REDTAIL RANCH FILING NO. 1

CONSTRUCTION DRAWINGS

PCD No. SF-18-021

Markup Summary

ULTIMATE VOLLMER ROAD CROSS SECTION

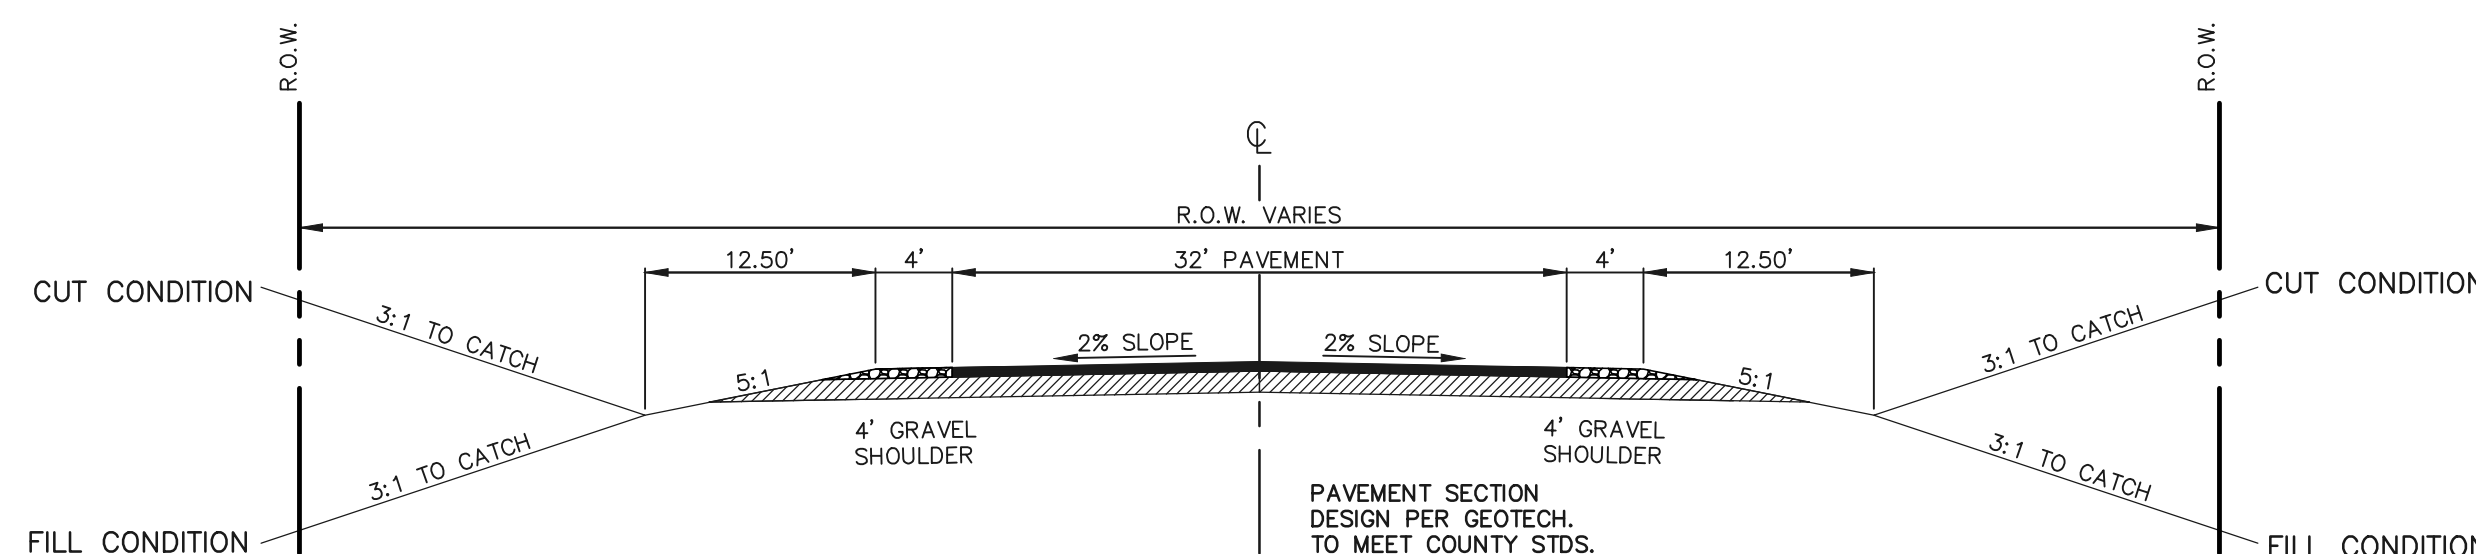
Provide Vollmer Road improvements cross-section(s) (for shoulder improvements per TIS).

GRADING & EROSION CONTROL PLAN

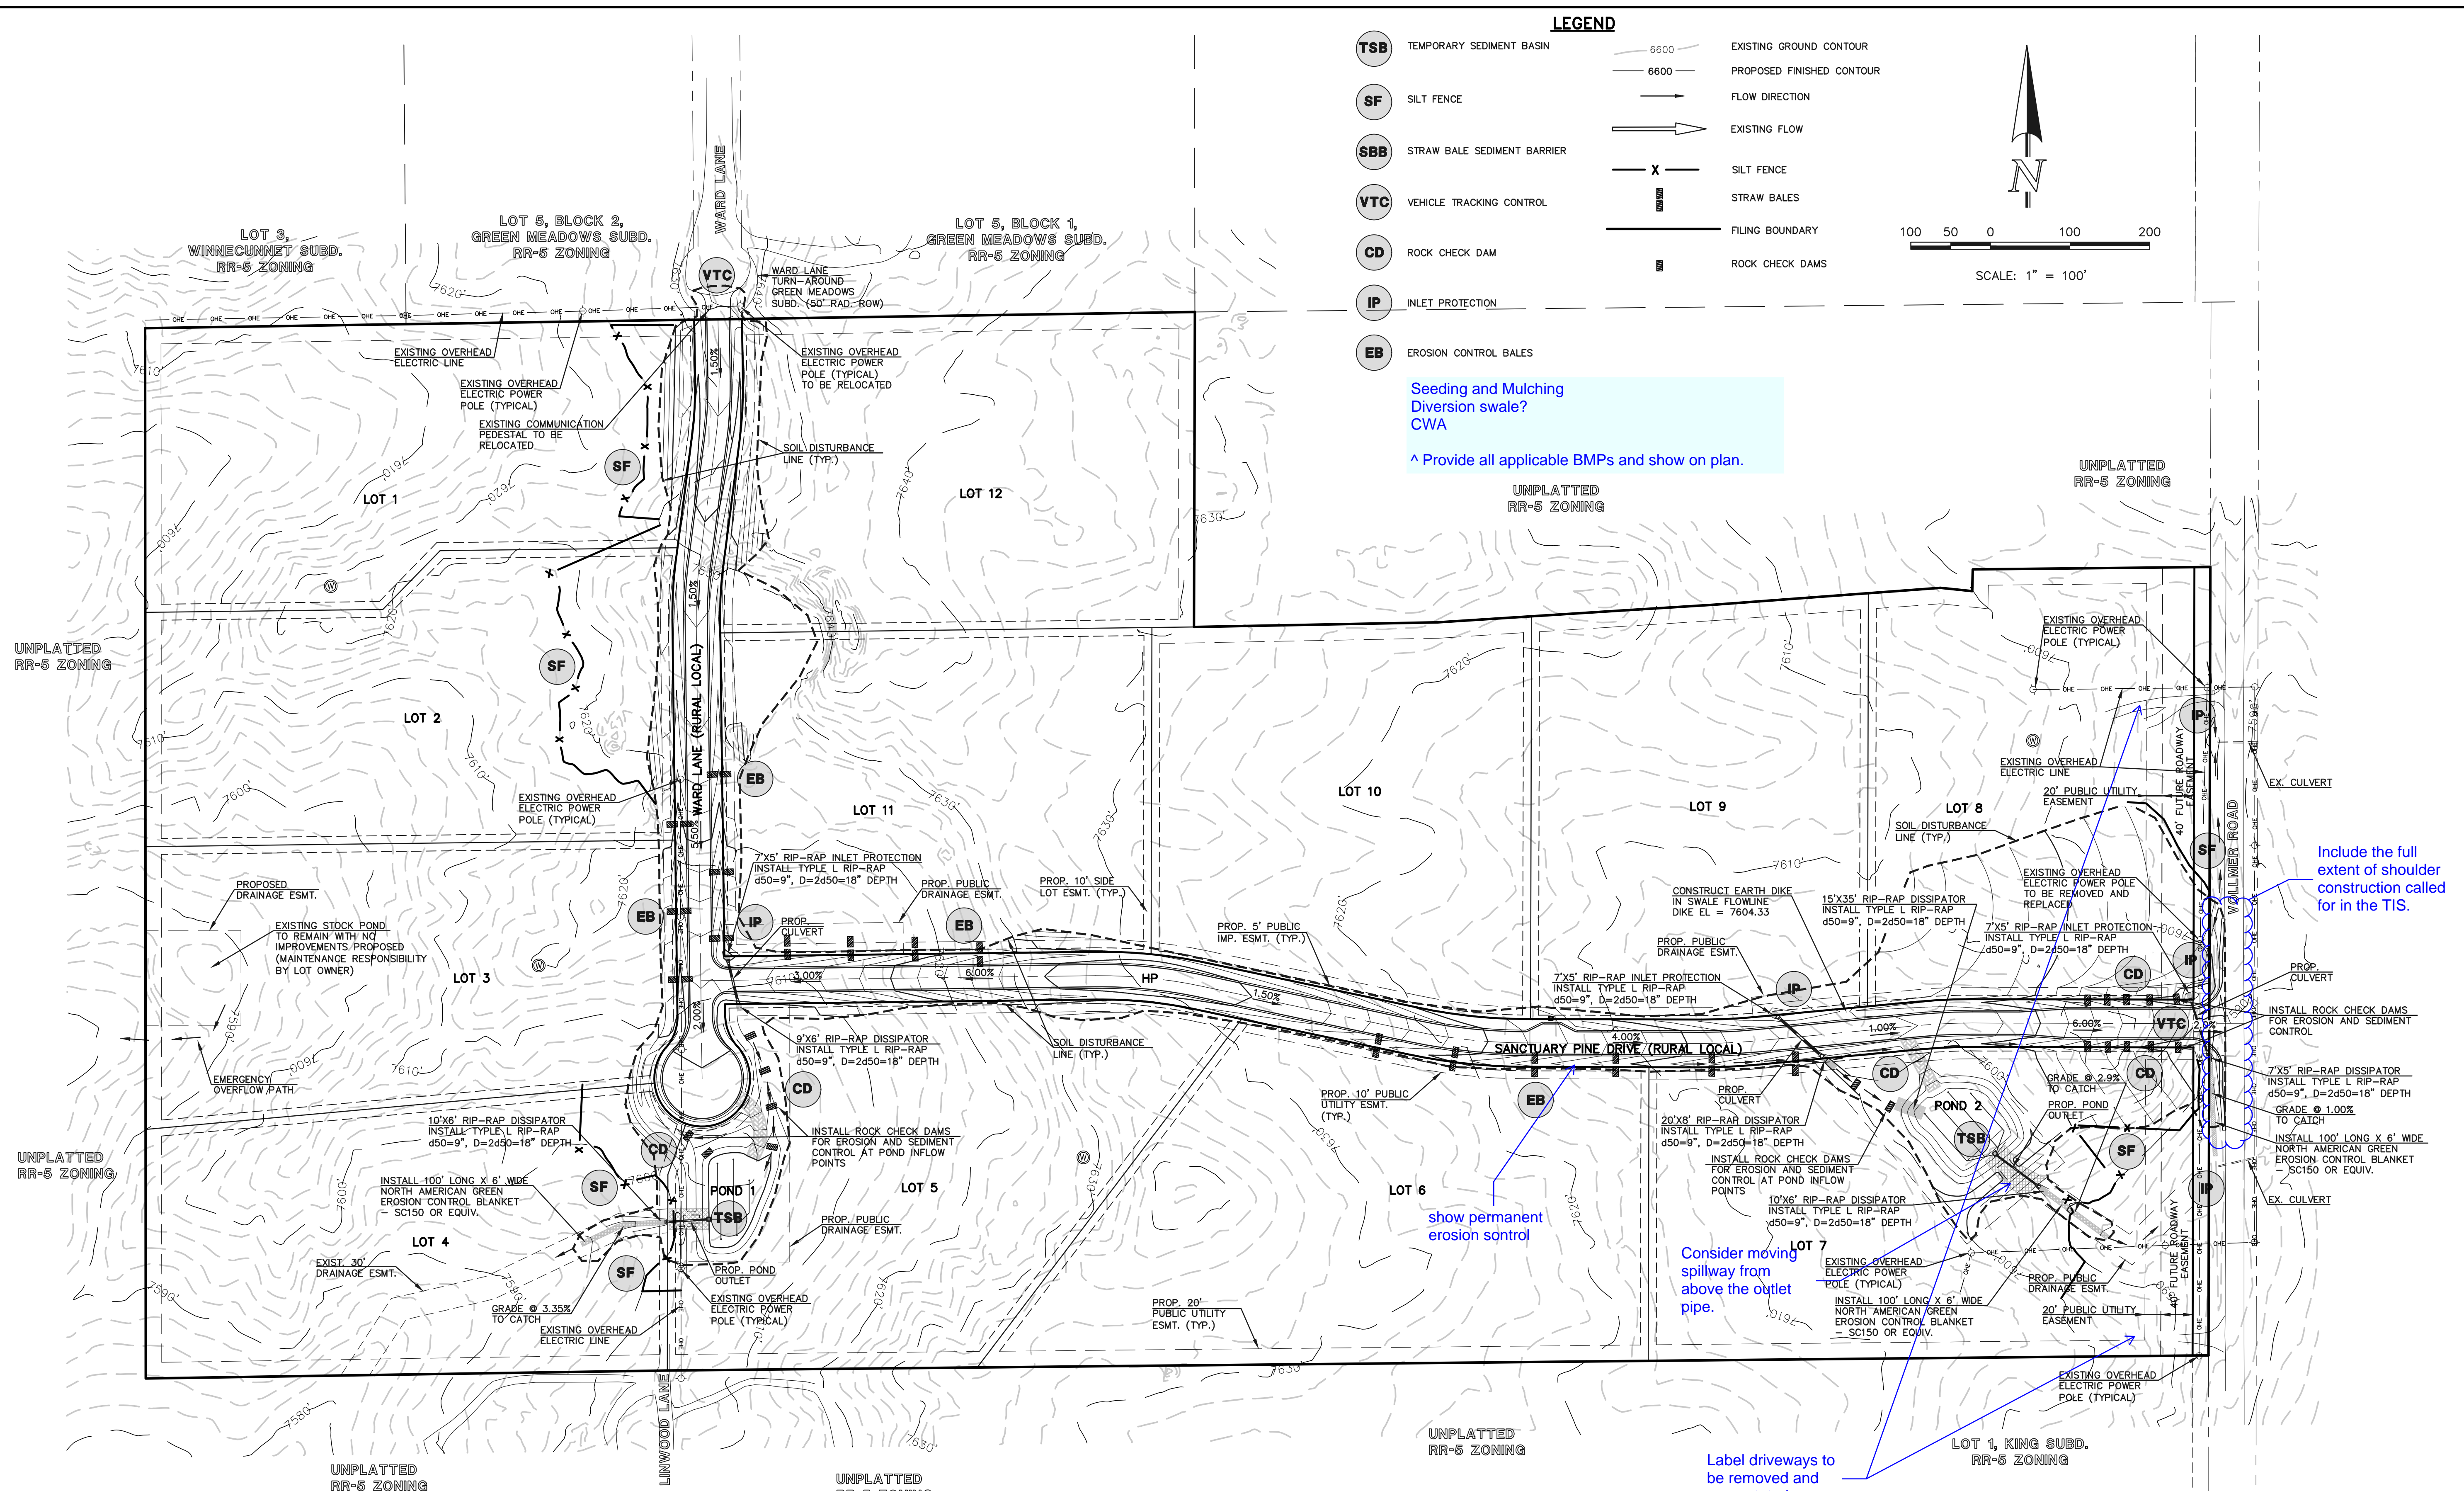
Seeding and Mulching
 Diversion swale?
 CWA

^ Provide all applicable BMPs and show on plan.

Include the full extent of shoulder construction called for in the TIS.

show permanent erosion control

Consider moving spillway from above the outlet pipe.

Label driveways to be removed and revegetated
